BUILDING PERMIT RECEIPT

Proposed Clay Electric District Office
SW S.R. 47
Lake City, Columbia County Florida

Proposed Clay Electric District Office
SW S.R. 47

TELLER WINDOW HEAD / CMU WALL

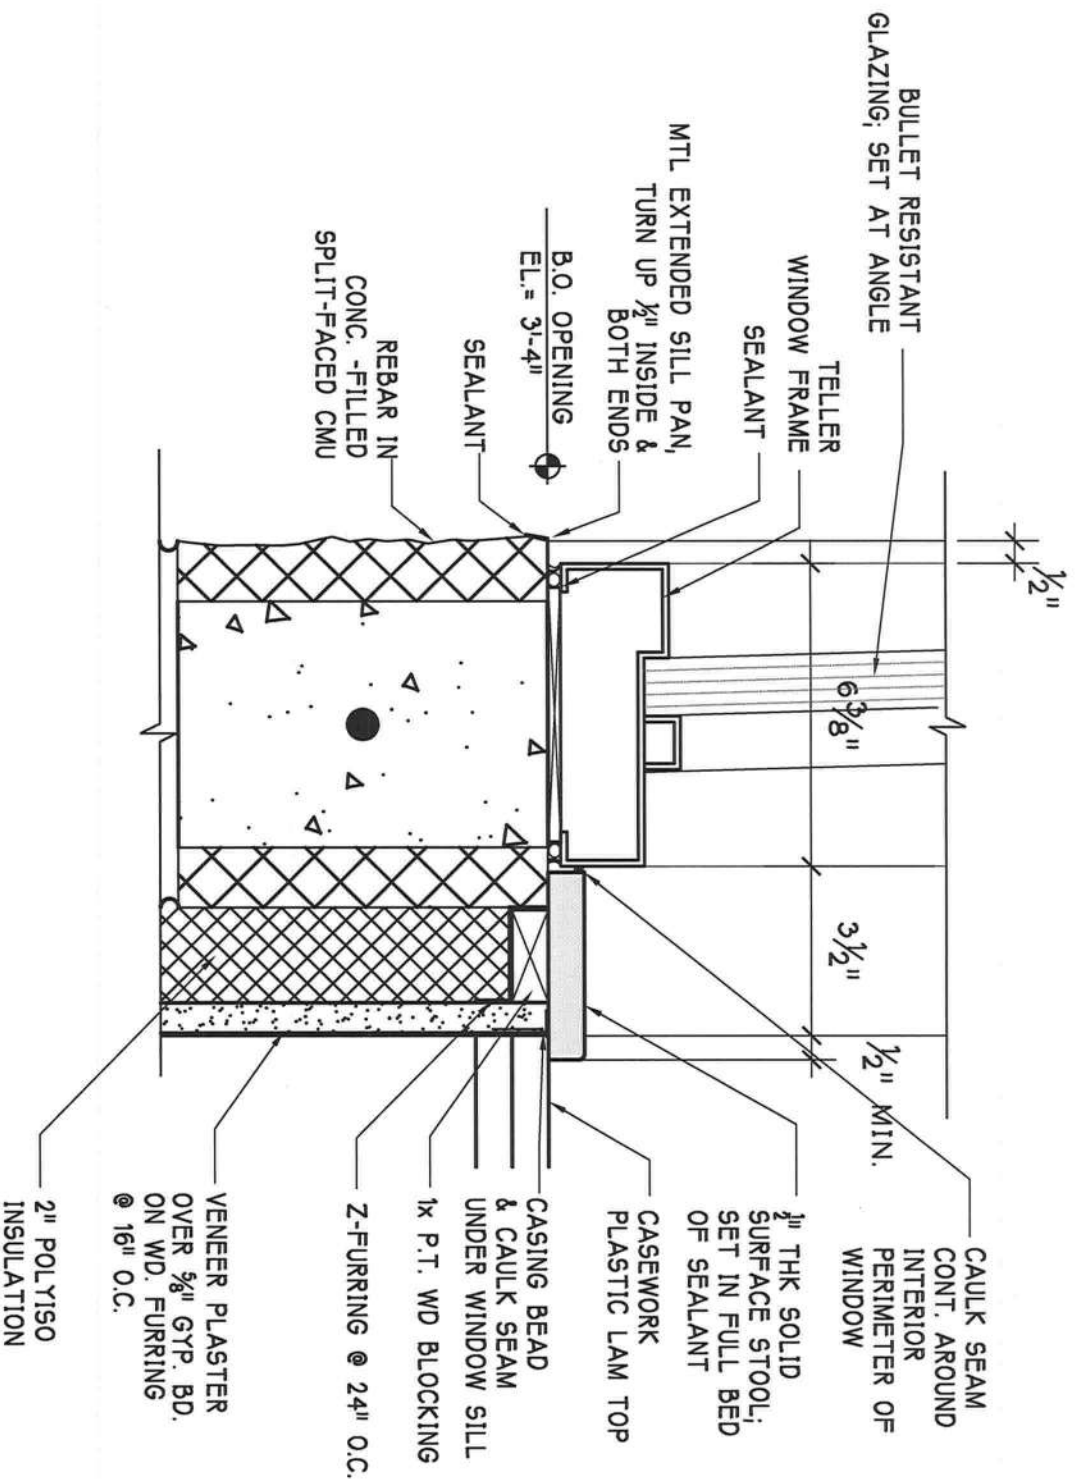
- Item 16** WINDOW HEAD / CMU WALL 4B/A2.2, delete this detail in its entirety and substitute in its place with that indicated on the attached drawing SK-1A, TELLER WINDOW HEAD / CMU WALL 4B/A2.2, dated 02/17/12.
- Item 17** WINDOW JAMB / CMU WALL 4D/A2.2, delete this detail in its entirety and substitute in its place with that indicated on the attached drawing SK-1C, WINDOW JAMB / CMU WALL 4D/A2.2, dated 02/17/12.

TELLER WINDOW SILL / CMU WALL

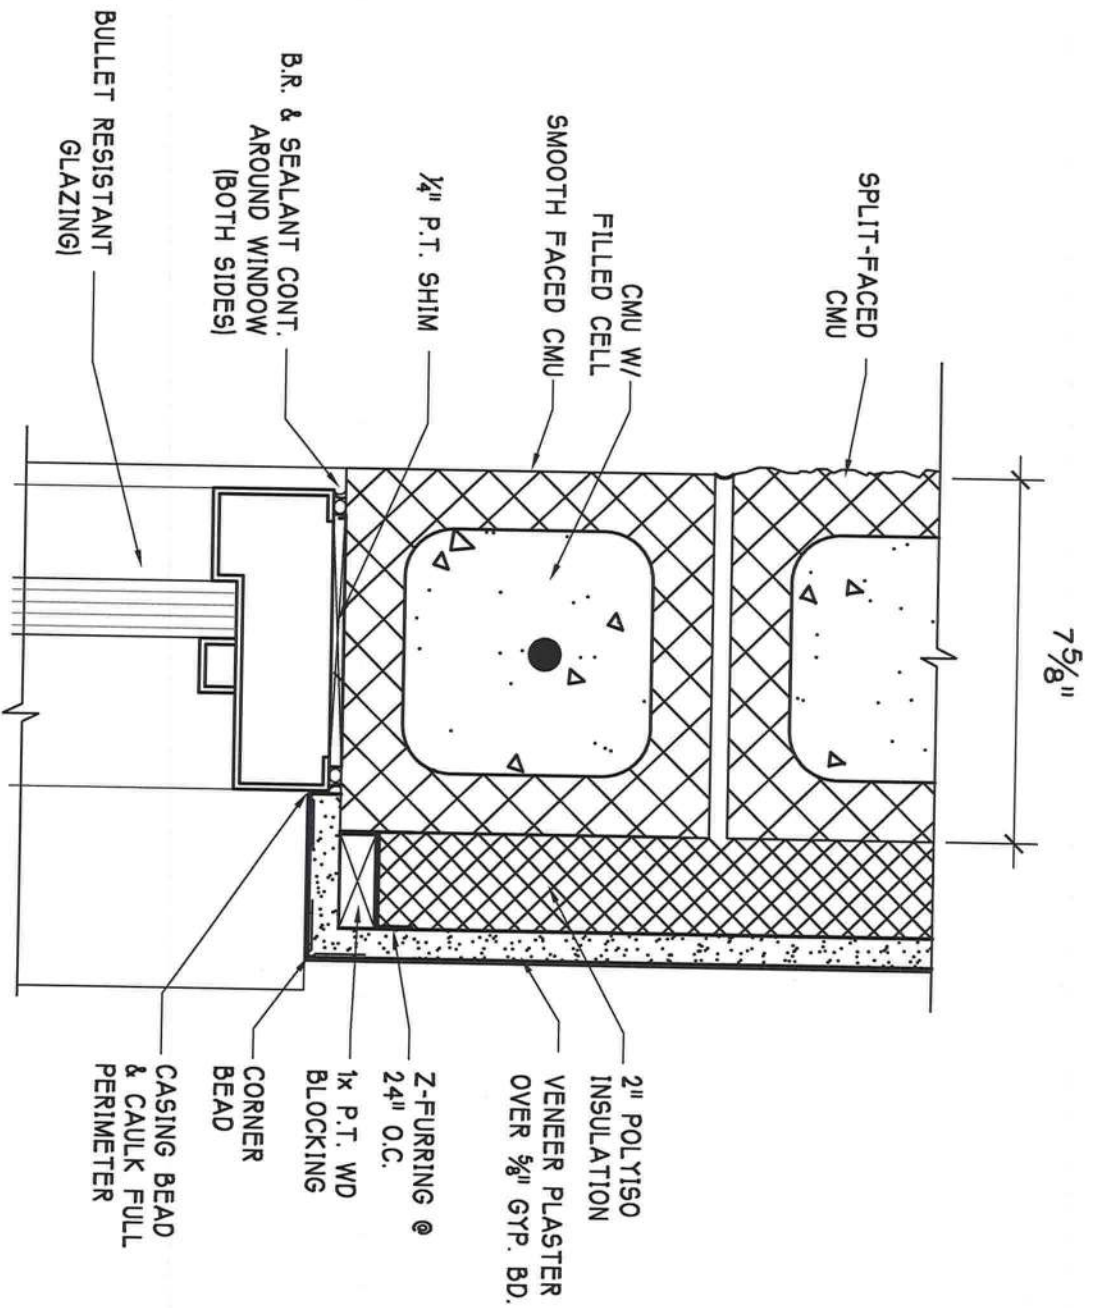
- Item 18** WINDOW SILL / CMU WALL 4G/A2.2, delete this detail in its entirety and substitute in its place with that indicated on the attached drawing SK-1B, TELLER WINDOW SILL / CMU WALL 4G/A2.2, dated 02/17/12.

66 WALL SECTION THRU DRIVE-THRU

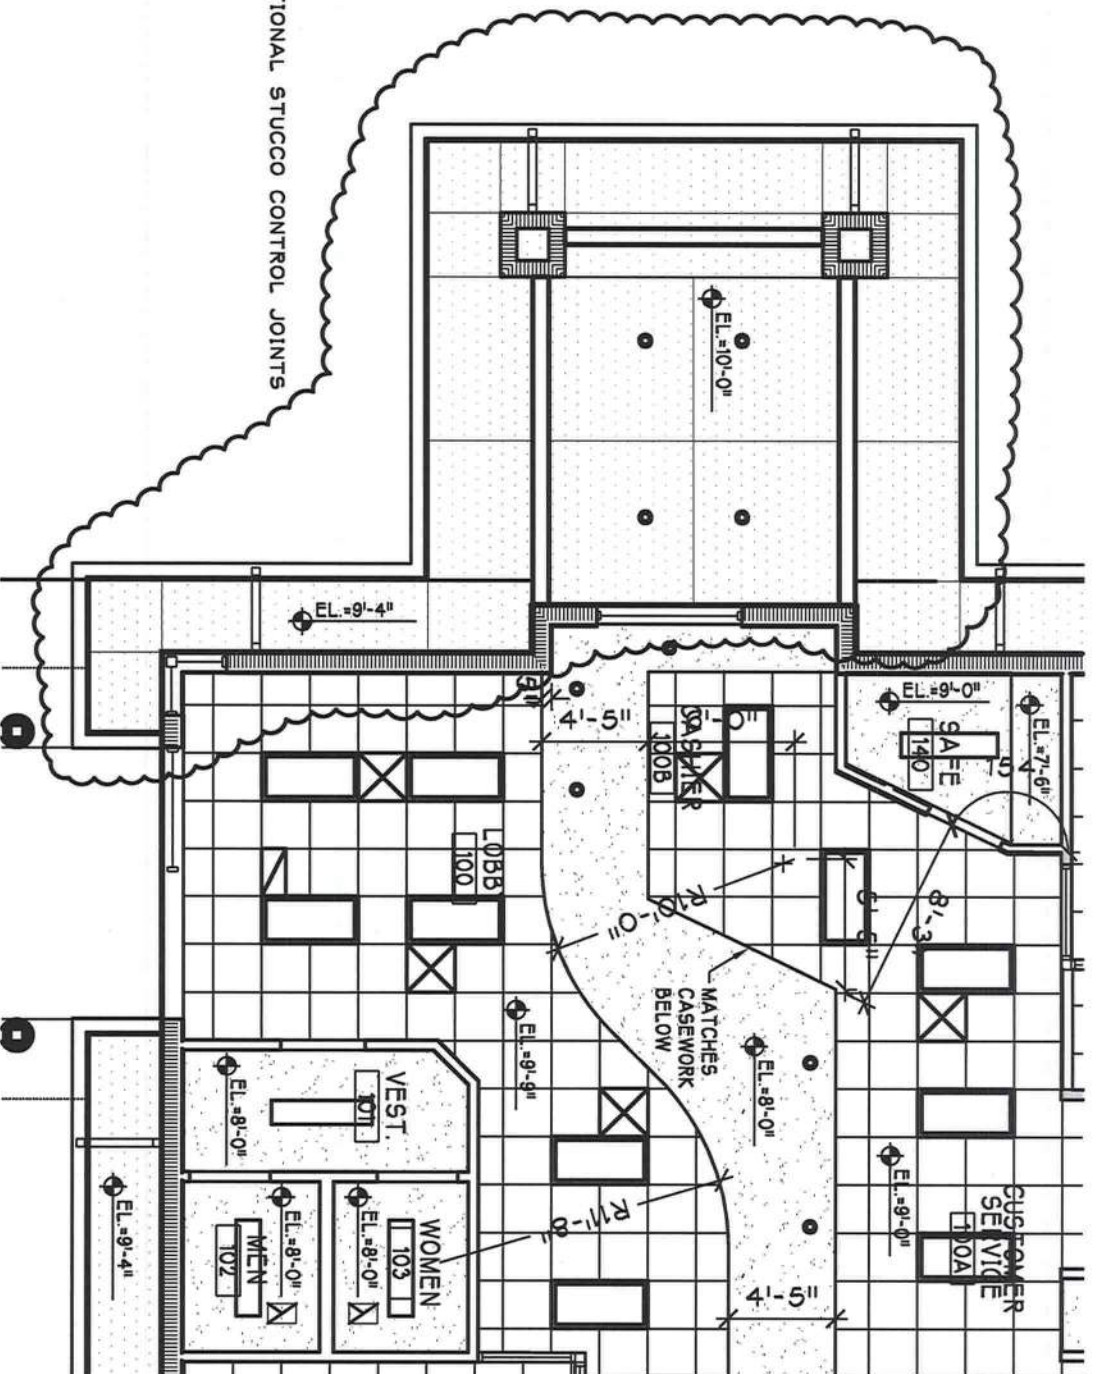
- Item 21** WALL SECTION THRU DRIVE-THRU 6G/A4.5, replace this Section with that indicated on the attached drawing SK-2, WALL SECTION THRU DRIVE-THRU 6G/A4.5, dated 02/17/12.

PARTIAL REFLECTED CEILING PLAN

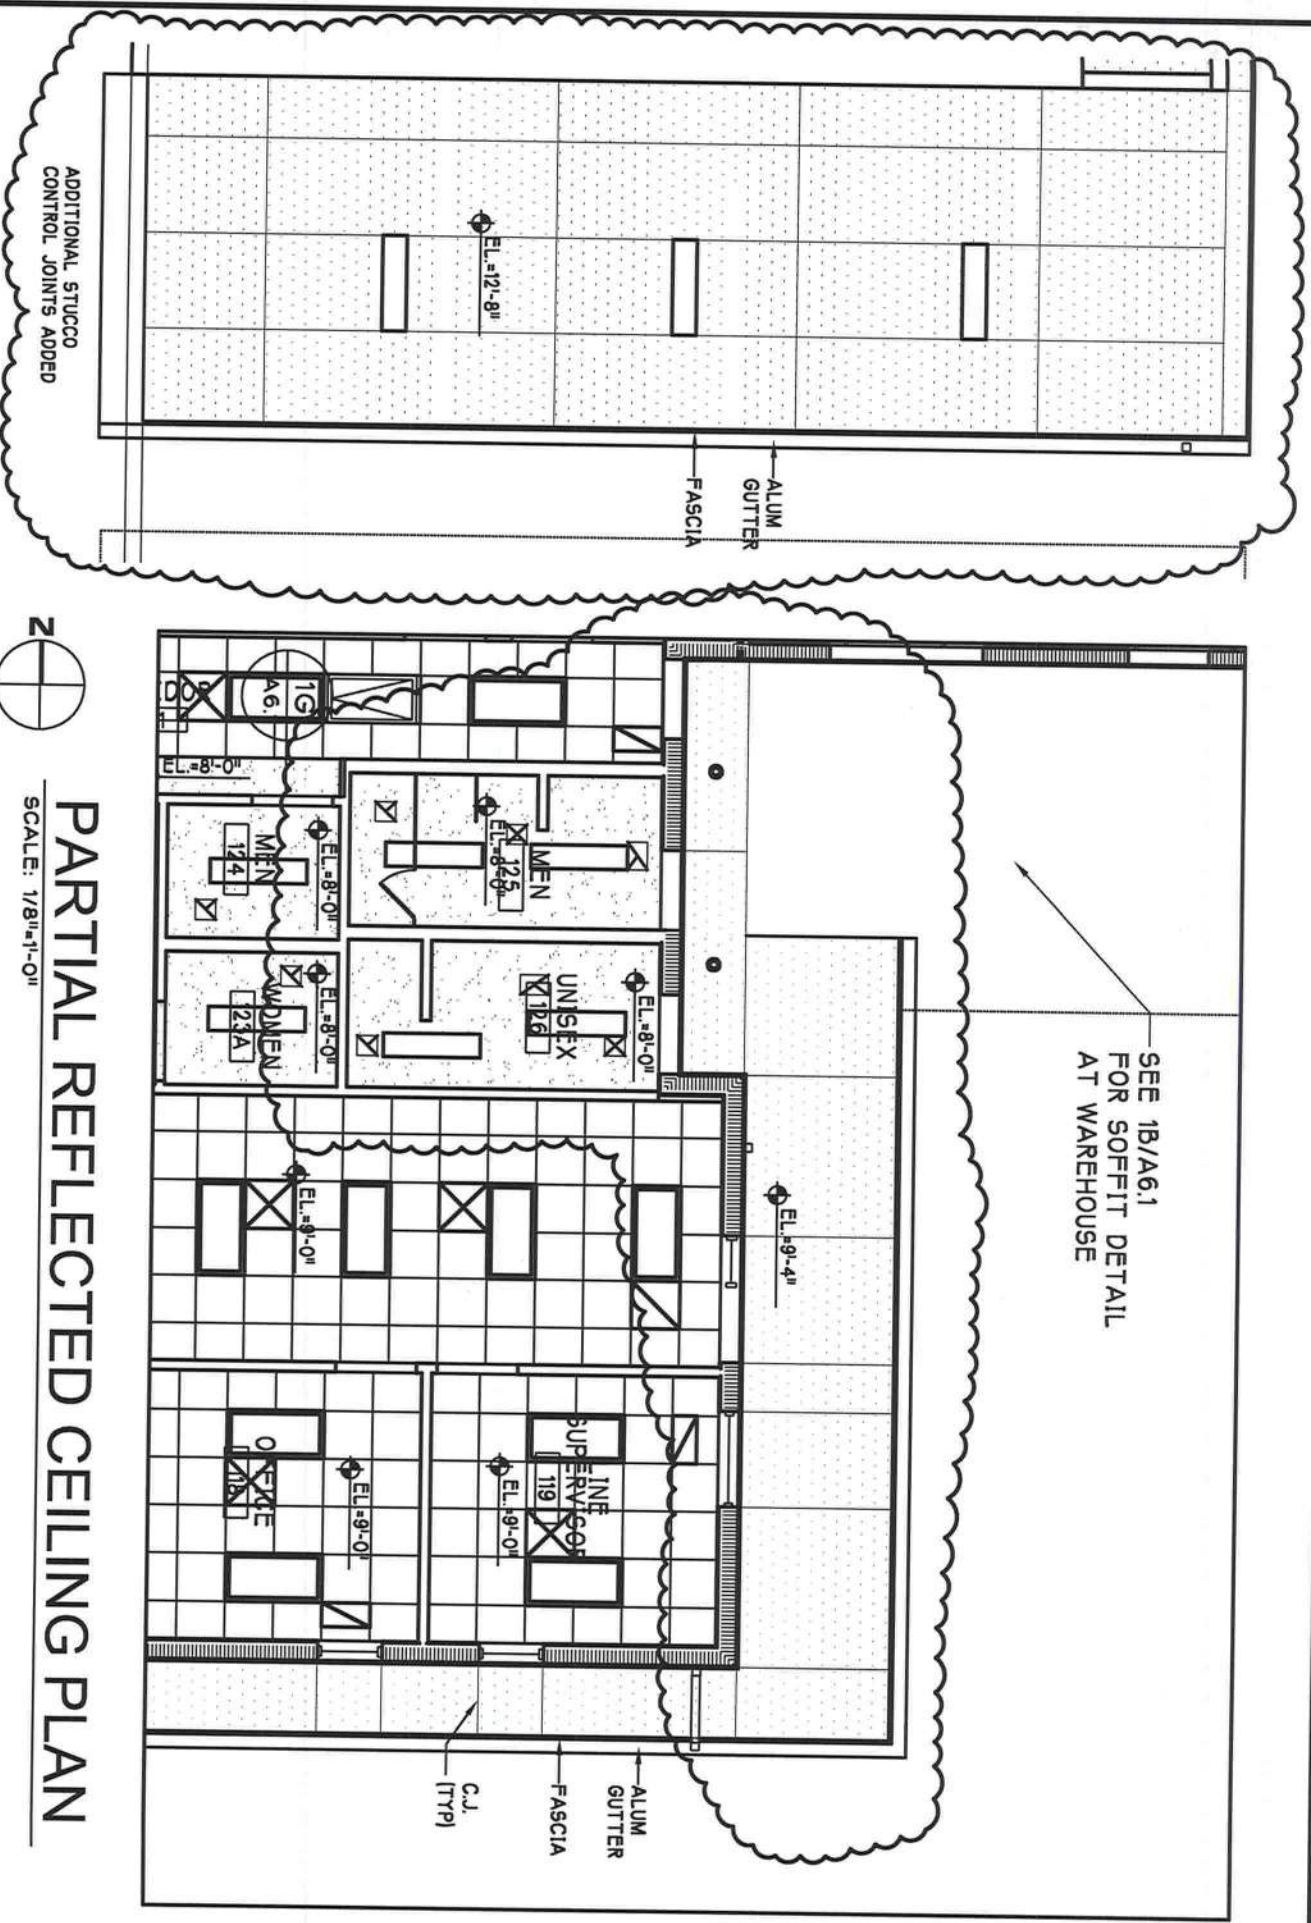
- Item 23** REFLECTED CEILING PLAN, add additional cement plaster (stucco) control joint locations as indicated on the attached drawings SK-3 and SK-4, dated 02/17/12.

F. PROVIDE BLOCKING AND BACKUP AS REQUIRED AT STUCCO CONTROL JOINT AND EXPANSION JOINT LOCATIONS.

TELCOM SITE PLAN
SCALE: 3/8" = 1'-0"

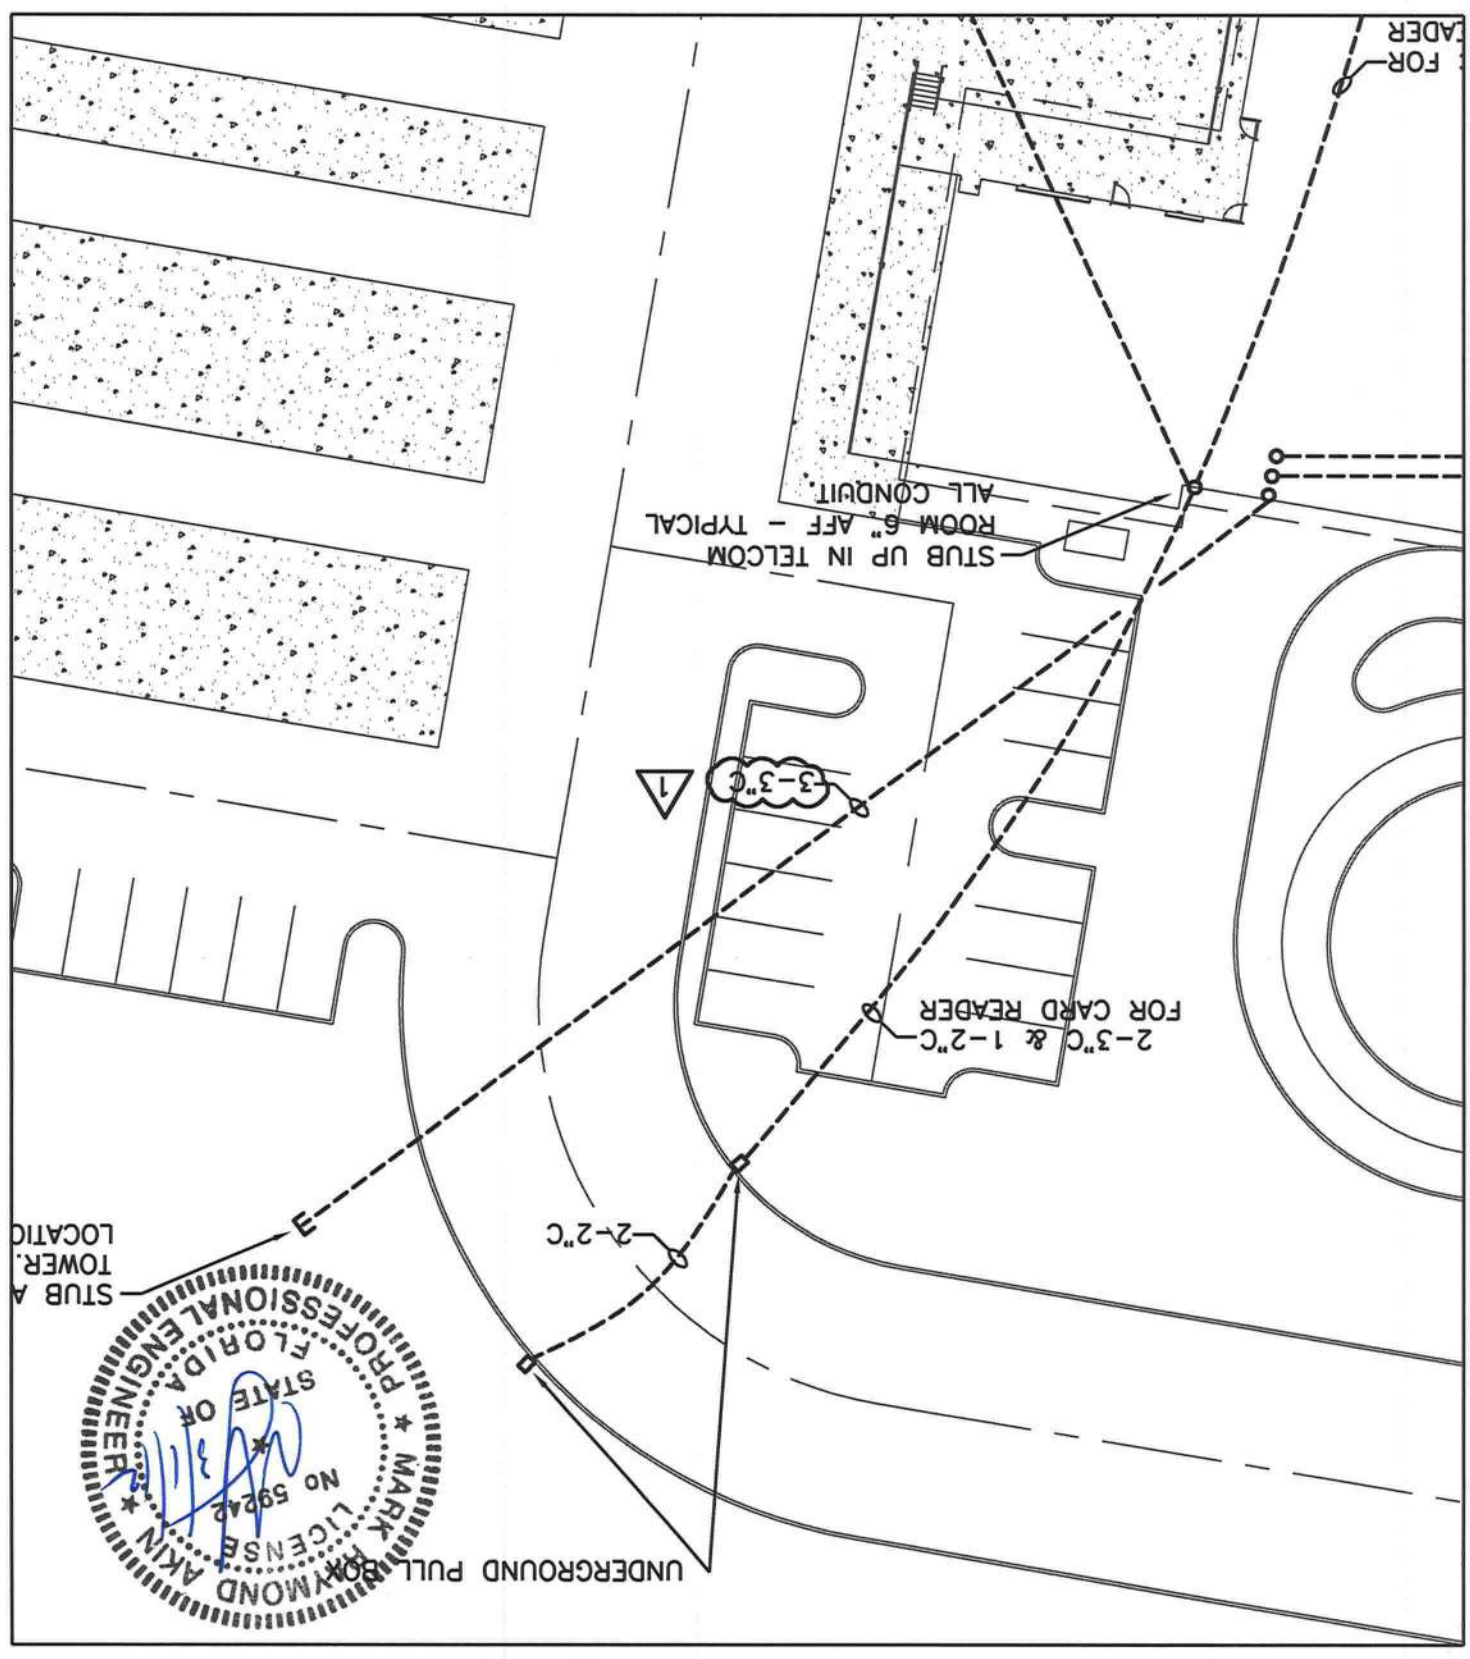
Item 28 TELCOM SITE PLAN, Revise sheet T0.2 as indicated on the attached 8 1/2 x 11 sheet T0.2a dated February 16, 2012.
